Access Compliance Report

Public Rights-of-Way

(Curb Ramps)

Intersection ID: 45757	Main Street: MOSS_GLEN_CT	Cross Street: GRANDEUR_RD	Location: NE
ADA ID: 41ADFEFBBF46	Ramp Type: PerpDiag	Initial Pass/Fail: Fail	Overall Compliance: No
Severity Score: 22.5			
Codes/Mitigation Info/Possible Solution		Field Measurements/Component Compliance

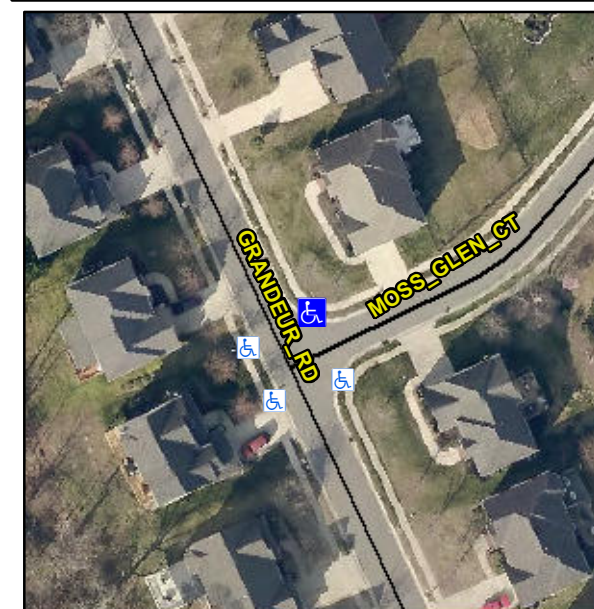
Not Found, R304.5.1, R304.2.2, R304.5.3

Compliance	Description	Data	Compliance	Description	Data
N/A	Ramp Length (in)	45.0	No	Ramp Slope (%)	9.2
No	Ramp Width (in)	41.0	No	Ramp XSlope (%)	3.2
N/A	Flare Type LT	N/A	N/A	Flare Type RT	N/A
N/A	Flare Slope LT (%)	N/A	N/A	Flare Slope RT (%)	N/A
N/A	Flare Traversable LT?	N/A	N/A	Flare Traversable RT?	N/A
N/A	Landing Length (in)	N/A	N/A	DWS Provided?	N/A
N/A	Landing Width (in)	N/A	N/A	DWS Contrast?	N/A
N/A	Landing Slope (%)	N/A	N/A	DWS Length (in)	N/A
N/A	Landing X Slope (%)	N/A	N/A	DWS Full Width?	N/A
N/A	Landing Curb? (Y/N)	N/A	N/A	DWS Offset (in)	N/A
N/A	Shared Landing?	N/A			
N/A	Gutter Ponding?	N/A	N/A	Gutter Slope (%)	N/A
N/A	Gutter Lip Ht (in)	N/A	N/A	Gutter X Slope (%)	N/A
N/A	Painted X Walk1?	No	N/A	Painted X Walk2?	No
	X Walk 1 Direction	To W		X Walk 2 Direction	To S
N/A	X Walk 1 Width (in)	N/A	N/A	X Walk 2 Width (in)	N/A
	X Walk 1 Slope (%)	1.3		X Walk 2 Slope (%)	4.0
	X Walk 1 X Slope (%)	4.9		X Walk 2 X Slope (%)	0.4

Remove & Replace Curb Ramp With Two New Directional Ramps or Equivalent.
